PSE IRP Consultation Update

Webinar 9: CETA Assumptions, Demand Forecast, Resource Adequacy, Resource Need

October 20, 2020

Summer loss of load events

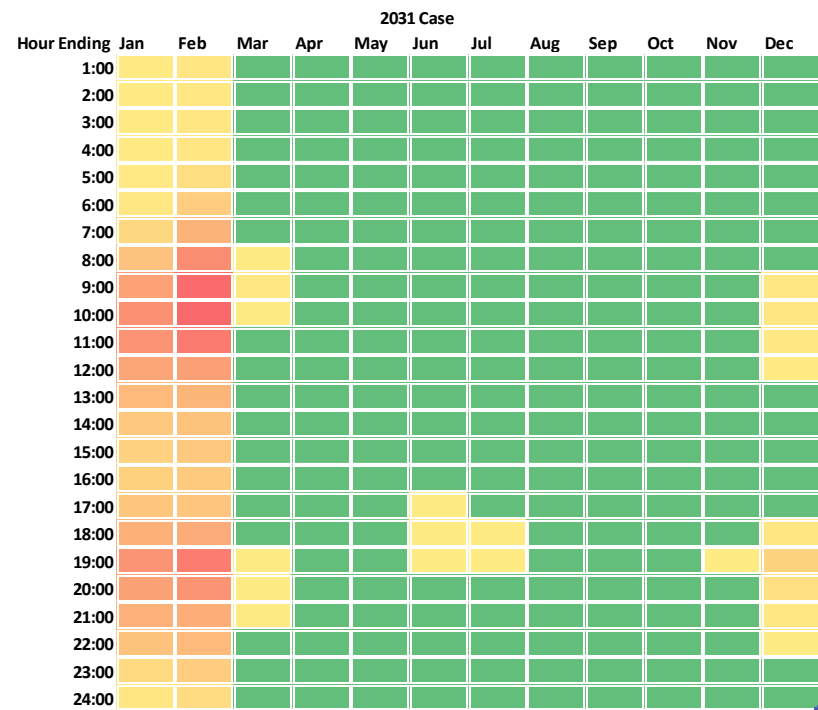
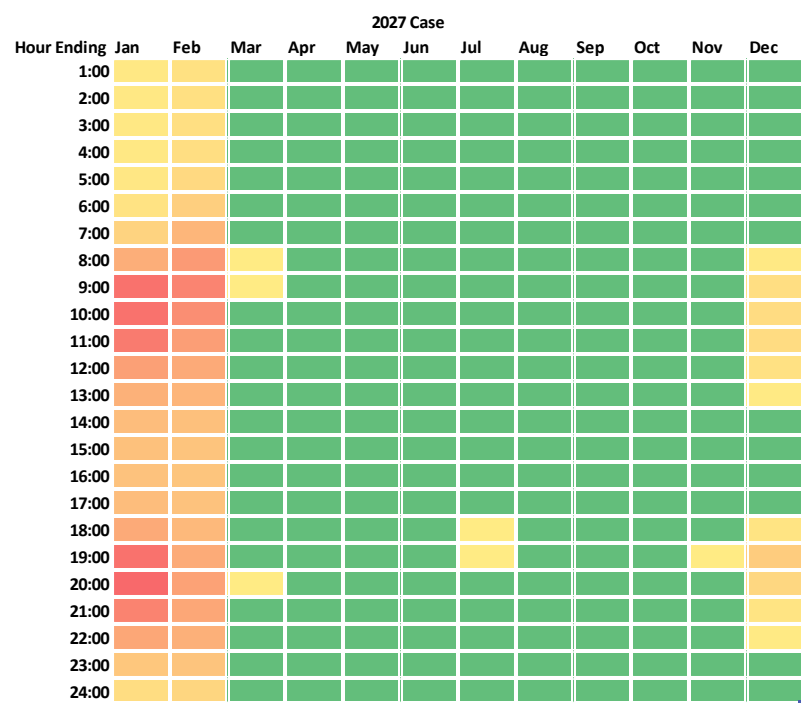
PSE received feedback from Katie Ware (Renewable Northwest), Kyle Frankiewicz (WUTC Staff) and Don Marsh (CENSE) concerning summer loss of load events. PSE would like to clarify that the demand forecast for the 2021 IRP process has not changed since its presentation during the [September 1 Webinar](#). However, an inconsistency with the demand forecast dataset used for Resource Adequacy modeling was identified and aligned. PSE regrets that our comments in the meeting, which only related to the Resource Adequacy dataset, gave the appearance that the demand forecast was changed.

Katie Ware (Renewable Northwest) had also requested a 12x24 of the loss of load probability as part of this feedback cycle. Given the methodology of the Resource Adequacy Model, PSE is not able to produce hour by hour probabilities, so instead these plots represent a relative heat map of the number hours of lost load binned by month and hour of day.

The summer-time loss of load events discussed during the meeting represent a very small fraction of the total loss of load events encountered over the course of a full year as shown in the tables below for the two test case years 2027 and 2031. A loss of load event can be caused by many factors which include temperature, demand, hydro conditions, plant forced outages, and variation in wind and solar generation. All of the factors are modeled as stochastic inputs simulated for 7,040 iterations. As mentioned previously, the data shared at the October 20 webinar are draft. PSE has been reviewing the data used for the resource adequacy model and found an inconsistency with the correlations for wind and solar data. PSE has fixed the correlations and is working on updating the peak capacity need and effective load carrying capability (ELCC) values. The table below has been updated since the November 3 feedback report to include the updates to the wind and solar correlations.
